Model : SM-G928A
Revision : REV 0.8
Manufacture Count :
Charge :
Contact :
Date :
Routing :
Resin :

Setup(2015-05-20)_HHP

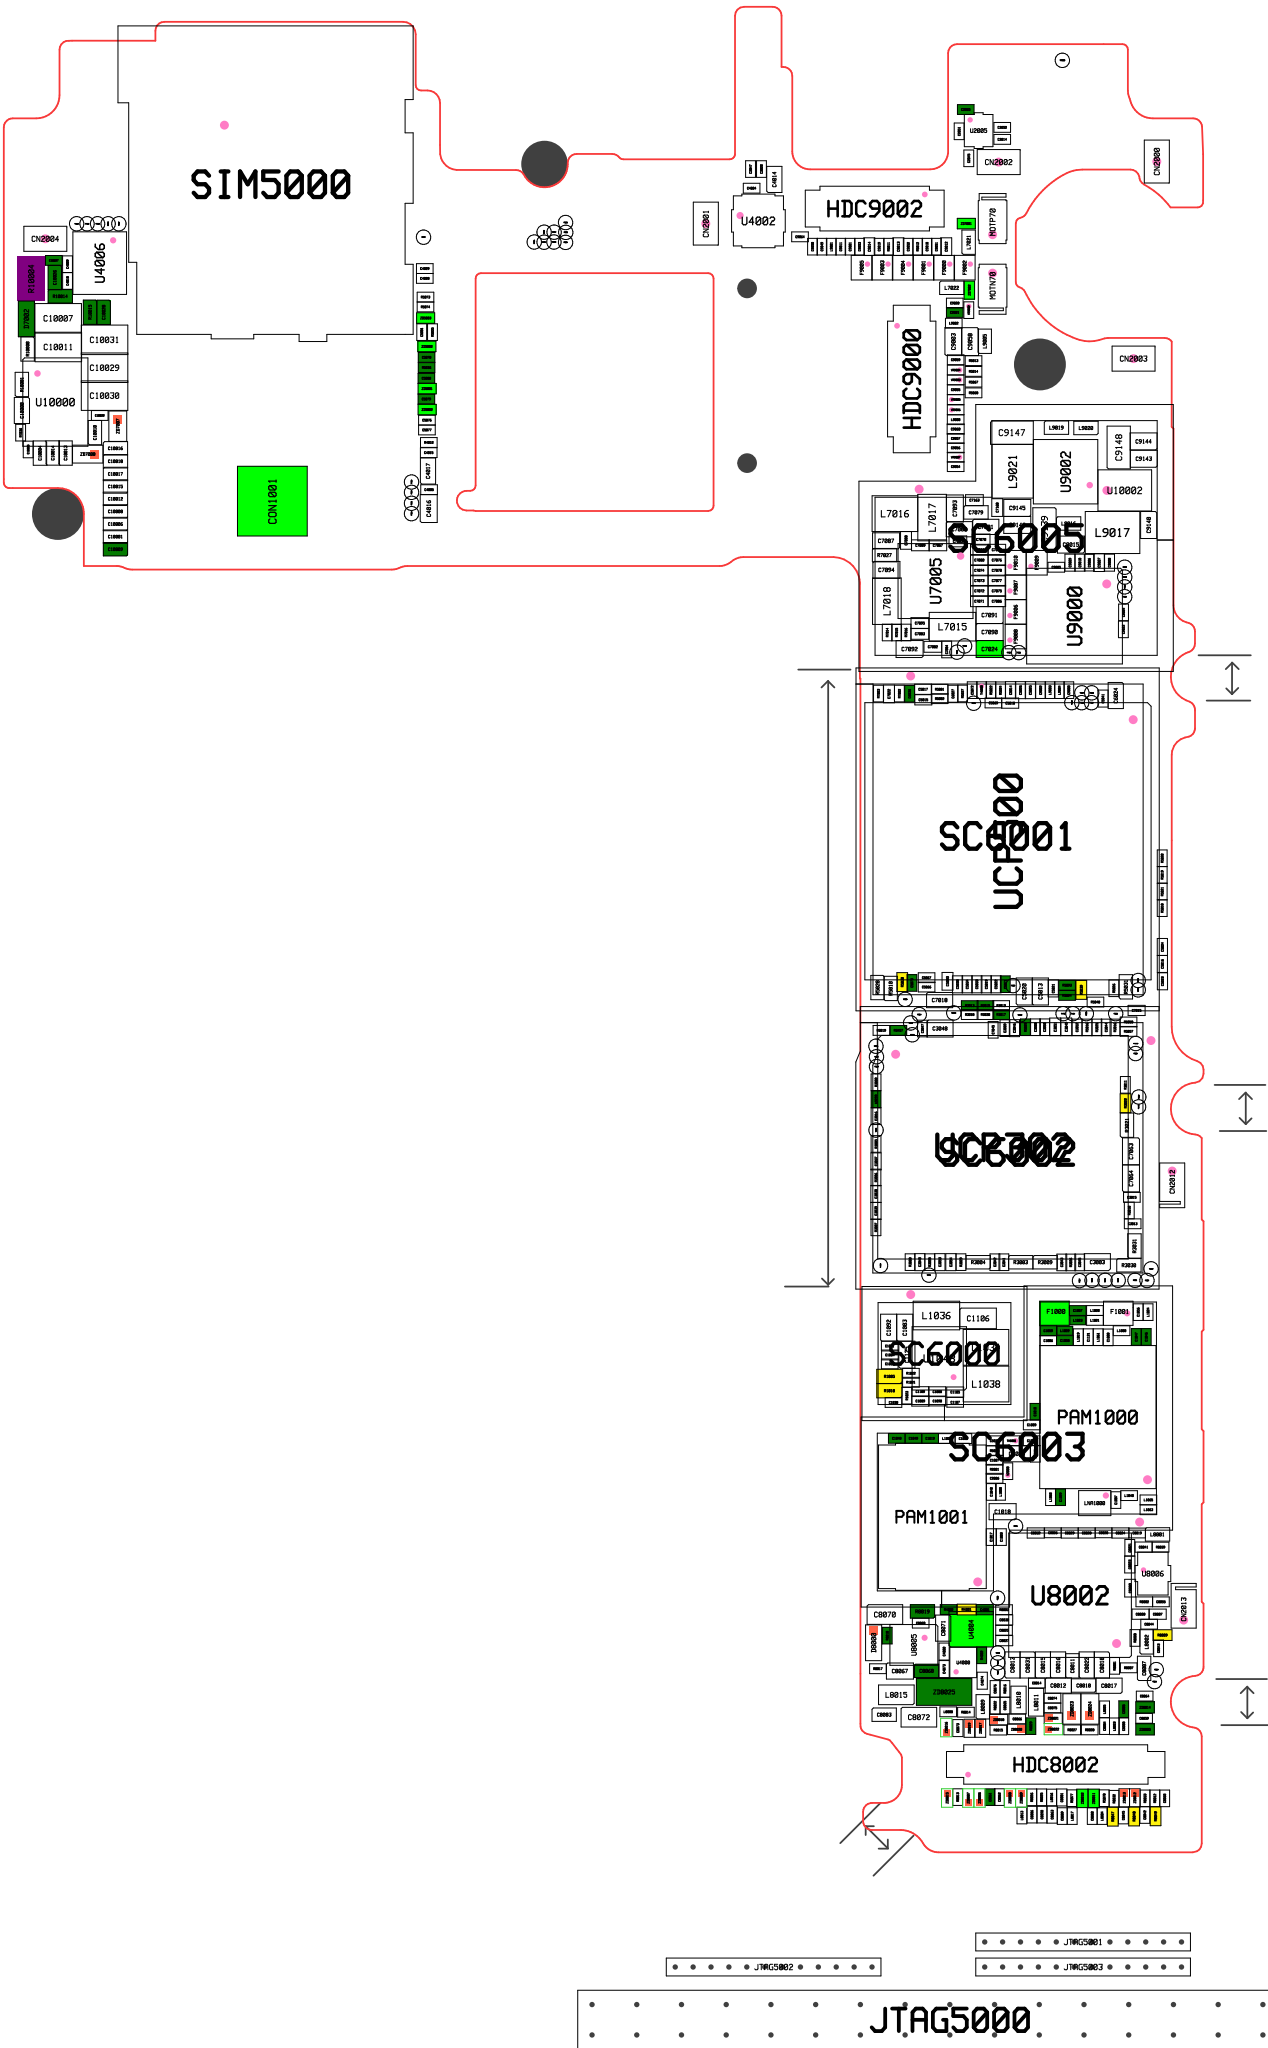
AON1605(TR7000) : IT'S Wrong Polarity possibility. Check the Pin1
2007-010848(R10004) : Check! Bottom Surface of Component
